100GBASE-BR10 Updated MPI Penalty Calculation: Support for comments against D2.2

June 24, 2024
IEEE Comment Resolution Meeting

Results:

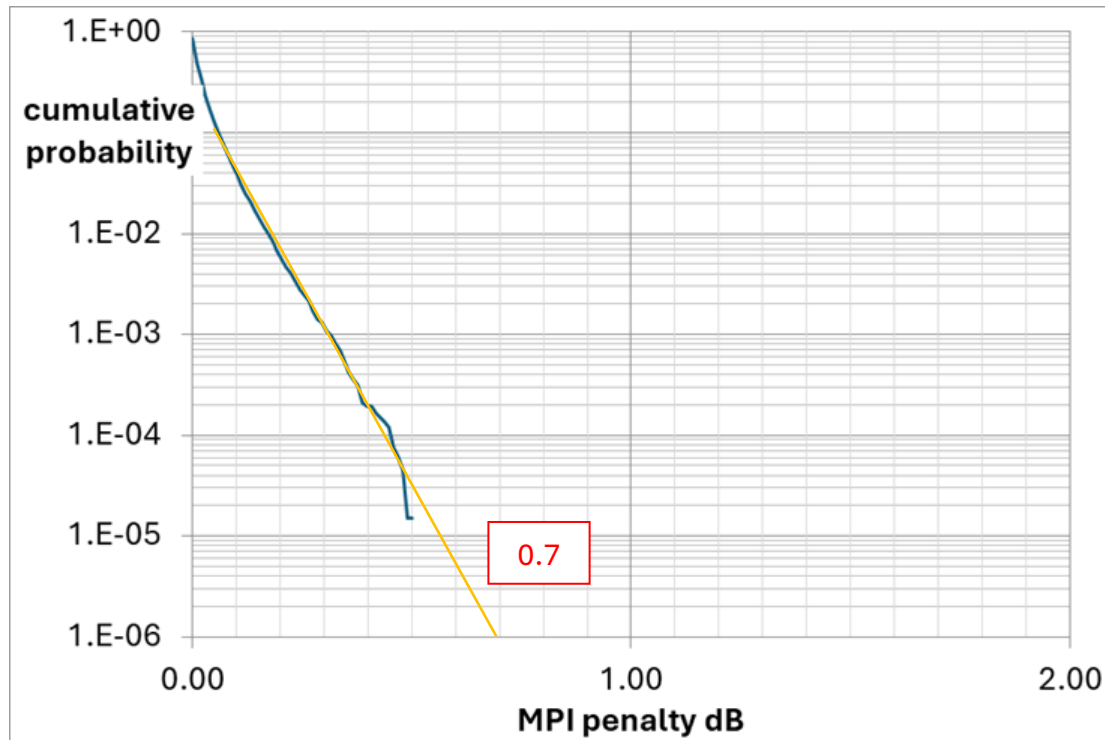
- MPI penalty for 100GBASE-BR10 recalculated to be less than current value.
 - Comments on D2.2 proposing to reduce power penalties and subsequently lower Tx launch values.
{Leave Rx values unchanged. Lower Tx launch should result in lower overall power dissipation.}
- MPI penalty for 100GBASE-BR20 in D2.2 is ok.
 - No change to D2.2.
- MPI Penalty for 100GBASE-BR40 in D2.2 is ok.
 - No change to D2.2.

100GBASE-BR10 MPI Calculation

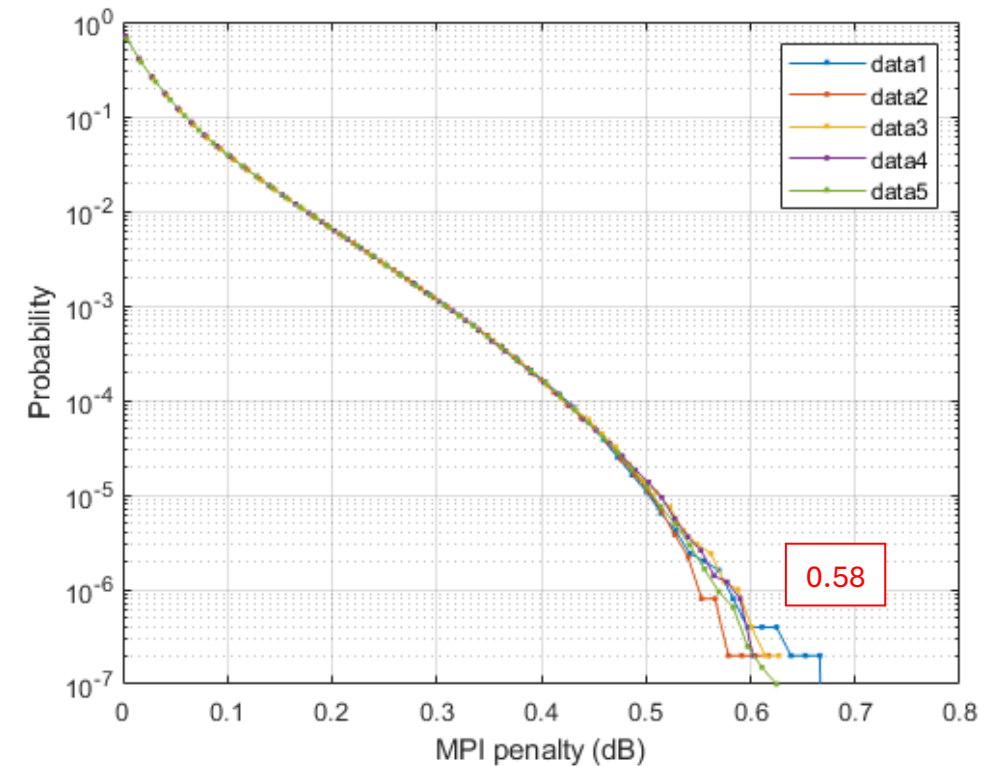
IL = 6.3dB; ER(min) = 3.5dB; 10 connectors: 4 @ -55dB, 6 @ -35dB
